SERVICE BULLETIN
SB0222 March 6th, 2023 Revision 01

BATTERY 443CH1 P/N 416470
One-way valve inspection

This Service Bulletin (SB) 0222 is a notification from Saft concerning design improvement of the battery 443CH1 Saft P/N 416470 one-way valve Saft P/N 415690.

Figure 001 – Gap between the one-way valve (370) Saft P/N 415690 with the vent tube

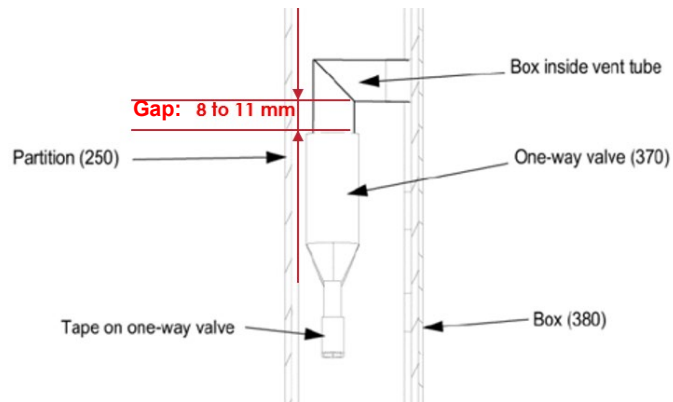
- Visual inspect the installed one-way valve (370) Saft P/N 415690 for any signs of cracks.
If crack on the one-way valve (370) Saft P/N 415690 is identified, example in figure 004, it shall be removed in accordance with point (3).
- Visual inspect the gap between the tube and the one-way valve (370) **Saft P/N 415690** as indicated in figure 001. The **gap must be between 8 to 11 mm**. The measurement is done visually or with an insulated tool.
If the gap is less than 8 mm, the one-way valve must be replaced in accordance with point (3)
If the gap is over 11 mm, adjust the one-way valve in the gap 8 to 11 mm to the tube.
- Else, if one-way valve (370) is not defective, install the complete cover point (5) or continue the maintenance tasks applicable.

Figure 002 – Detailed view one-way valve (370) location and clearance for handling.

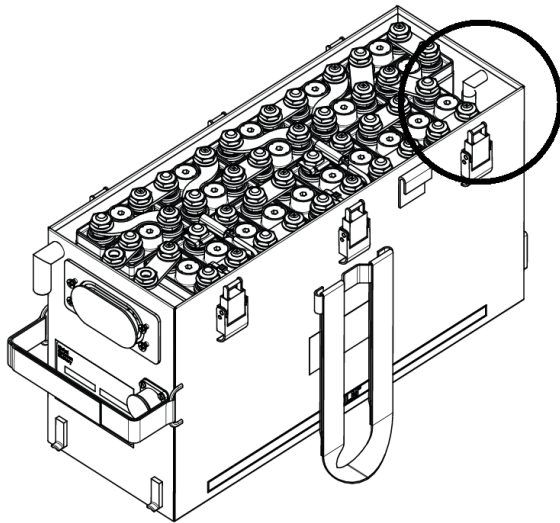
- Remove the one-way valve (370) by gently pulling on the one-way valve to remove it from the vent tube, refer to figure 002.
- Scrap the defective one-way valve (370).

- Install the new one-way valve (370) from inside the box (380) on the box vent tube, refer to figure 002.
- Make sure that the one-way valve (370) Saft P/N 416710 is installed fully and reaches a stop as indicated on the schematic in figure 003 (to 90° tube).
- Once replacement done add on the battery logbook in the column “comments” the following mention: “SB0222 applied”.
